Frame Alignment Requirement in Relays

Gamini Senarath, Hang Zhang, Peiyong Zhu, Mo-Han Fong, Wen Tong, Israfil Bahceci, David Steer, Derek Yu, Mark Naden, G.Q. Wang

Nortel

8.4.4.7.2.2 Relay frame structure

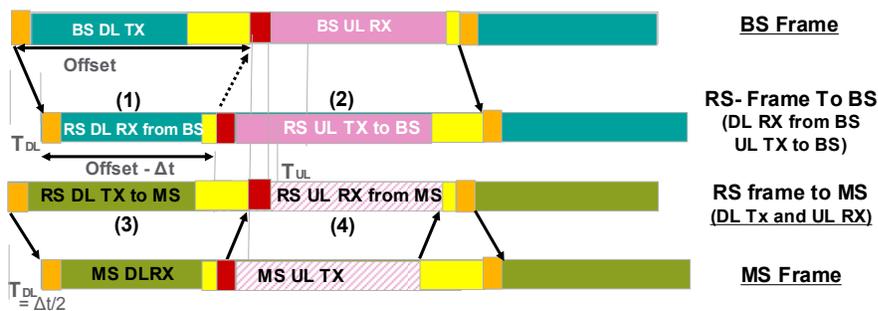
[Insert following text into 8.4.4.7.2.2]

XXX Alignment Requirements for Relay Transmission and receive frames for communication with its child nodes (RS and MS).

In order to achieve proper operation, the relay downlink transmission to its children (RS or MS) should be time-aligned with the MR-BS's downlink transmission to its children (RS or MS).

For the TDD mode, an example of an RS frame structure is shown in Figure <xxx>.

- Frame (1) is T_{DL} duration delayed and Frame (2) is T_{UL} duration advanced relative to the BS frames.
- Frame (3) is fully aligned with BS TX and Frame (4) is fully aligned with BS RX.
